Work Order ID 101948

Item Name: Crosstube Fwd High

DART AEROSPACE LTD	Work Order: 101948
Description: Crosstube High Fwd (205/212/412)	Part Number: D212-664-101
Inspection Dwg: D212-664-141 Rev: D	Page 1 of 1

DRAWING NO. D212-664-141	TITLE XTUBE ASSY (205/212/412 HI FWD)	REV. D	DART AEROSPACE LTD ENGINEERING ORDER		D.E.O. NO. D212-664-141-D-1	SHEET NO. SHEET 1 OF 2	SCALE NTS
DRAWN	CHECKED	MFG. APPR.	APPROVED	DE APPR.			
DATE 11.04.07	DATE 11.04.11	DATE 11.04.12	DATE 11/04/12	DATE 11.04.12

**D212-664-141/-141B
ASSEMBLY DETAIL**

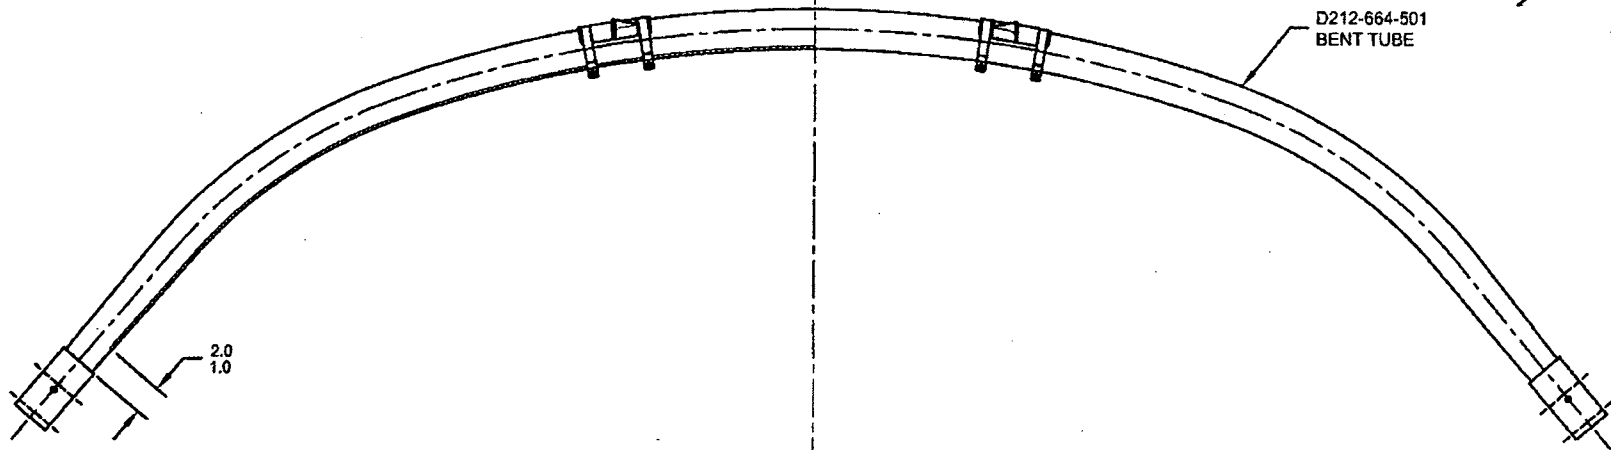
ADD AN INSPECTION WINDOW TO UNDERSIDE OF CROSSTUBE.

NOTES 2 OF SHEET 1 IS AMENDED AS FOLLOWS:

MASK AREA PRIOR TO PAINTING,
REMOVE MASKING AFTER PAINT
AND APPLY CLEAR COAT

- 2) FINISH: CHEMICAL CONVERSION COAT PER DART QSI 005 4.1
PRIME INSIDE AND OUTSIDE PER DART QSI 005 4.2
MASK UNDERSIDE OF CROSSTUBE AS SHOWN (HATCHED AREA) AND
PAINT OUTSIDE PER DART QSI 005 4.2
REMOVE MASKING AND APPLY CLEAR COAT
